**Appendix 9**

# The Old Power Station, Design Addendum

## 12 November 2020

This document has been produced in response to the comments received on 22 October 2020 from Darren Cook, Transport and Development Control Manager, and Mark Worringham, Area Planning Team Leader.

**Figure 1.15**  
**Alternate Route Option 2 –**  
**Descend from Crossing**

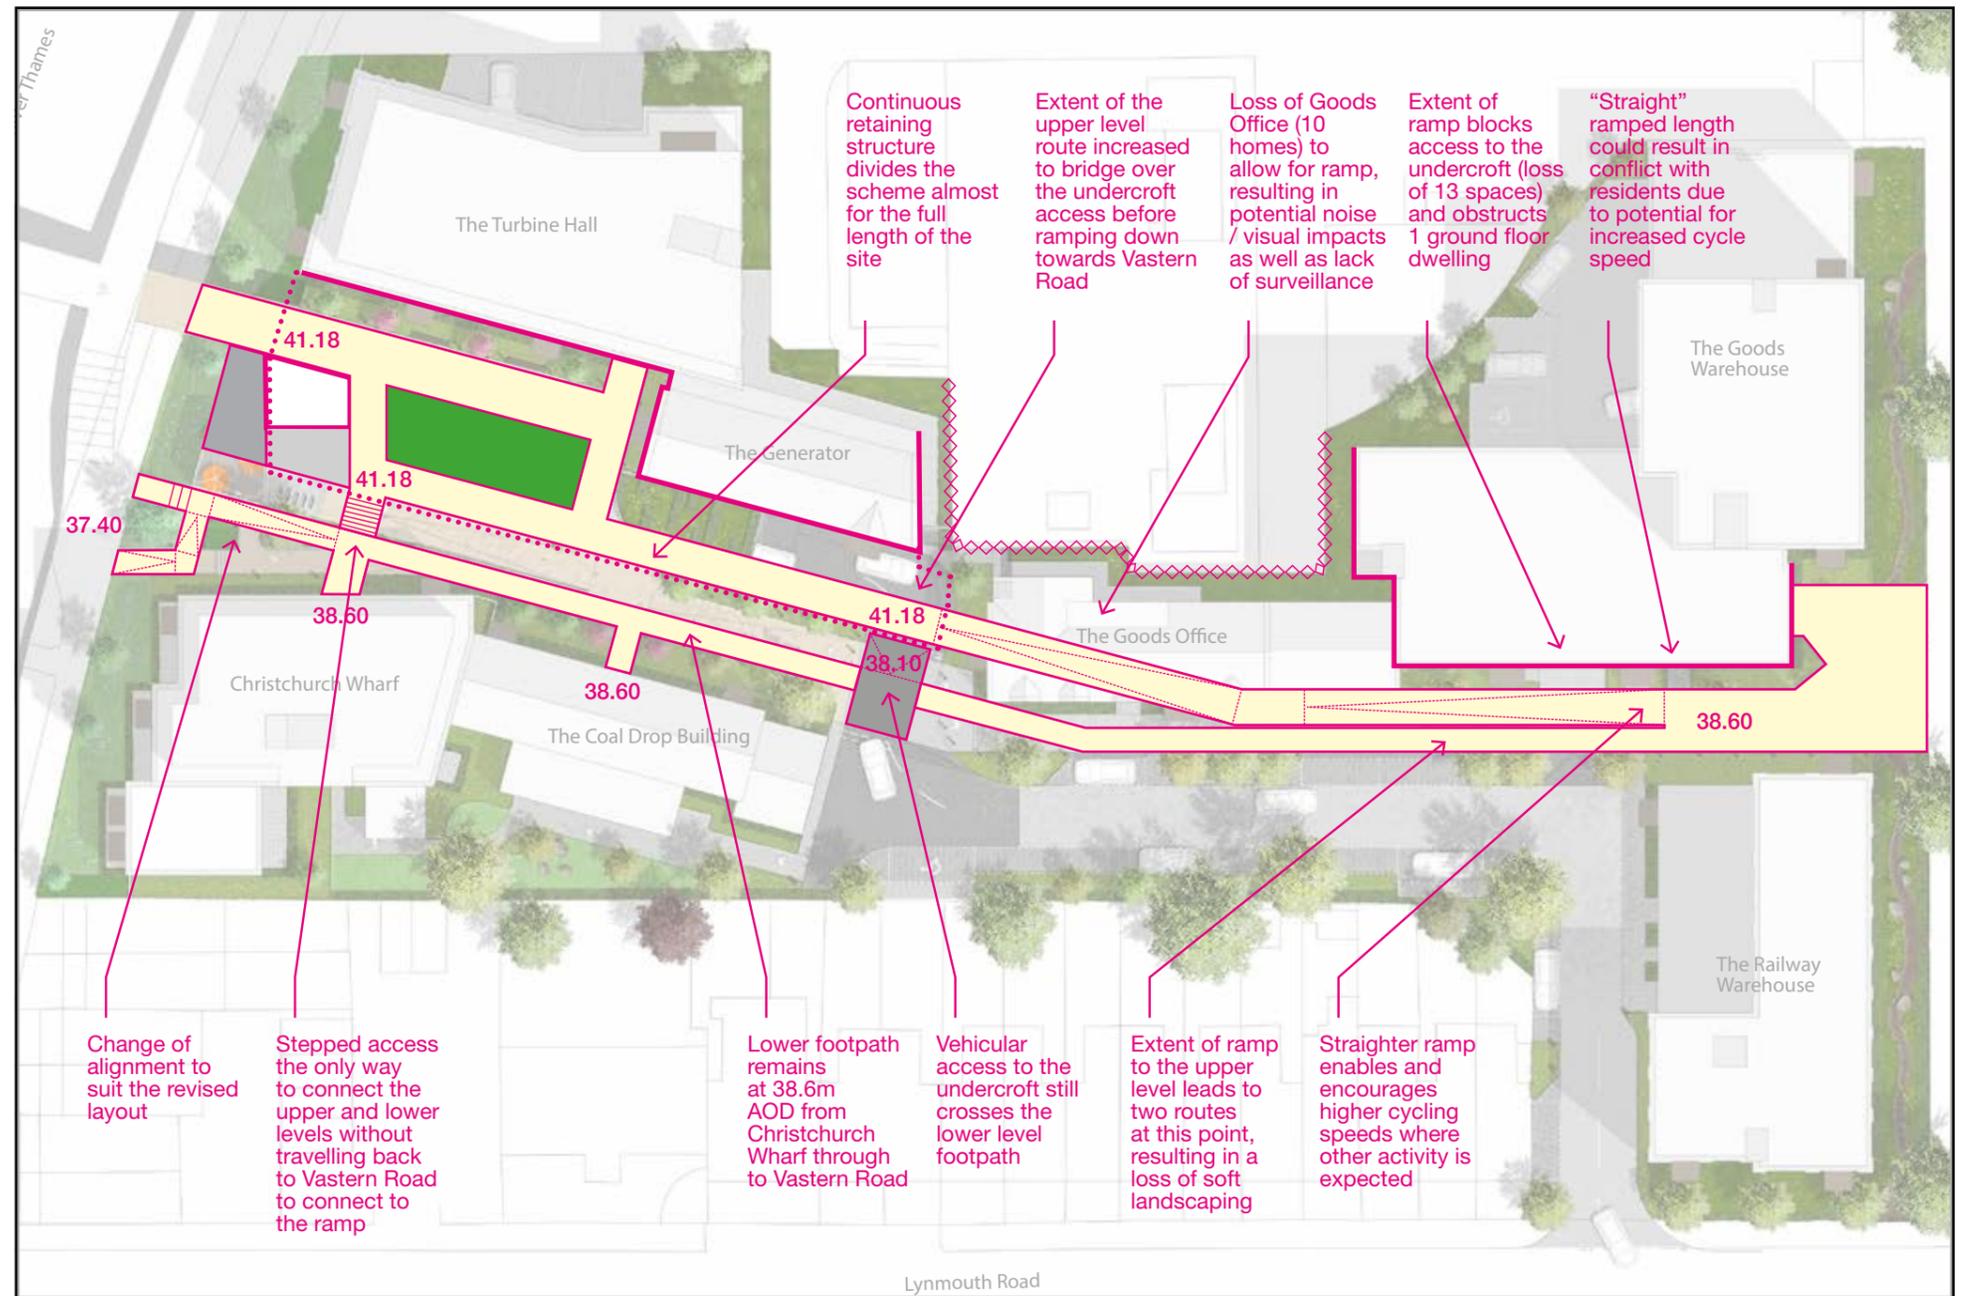
As an alternate option, a more linear route has also been investigated as follows. For the purpose of this sketch, it is assumed the Towpath connection is 2m and the Bridge connection is 3m.

From Vastern Road, the route would be at 5m in width, splitting in to a 2m route to the Towpath and a 3m route to the Bridge to the corner of the Railway Warehouse building.

The towpath route would remain alongside the road and parking at a level of 38.6m AOD up to the entrance of Christchurch Wharf. From this point the route would descend at 1:21 to the towpath, with a more direct stepped connection if required. This would result in the Coal Drop Building dropping in height by almost 1m due to the revised ground floor level to tie-in to the footpath. This lower route would still cross the vehicular entrance to the undercroft.

The Bridge route would begin climbing through the site much closer to Vastern Road, allowing the route to run over the vehicular entrance to the undercroft. From this point, the route would remain at 41.18m AOD through to the connection to the Bridge.

In this scenario the whole of the ground floor of Christchurch Wharf and Coal Drop Building would be facing on to a 3.7m high structure which would support the foot / cycleway, under which would be the undercroft.

to access the Turbine Hall and Generator buildings. The Goods Office would need to be removed, resulting in a loss of 10 homes. Access to the undercroft on the Goods Warehouse would be blocked by the ramp, resulting in a loss of 13 parking spaces. This would also require the loss of 1 more home due to the ramp. A revised refuse strategy would also be required for this building. With no building to screen the SSE equipment, views and noise would then become an issue.
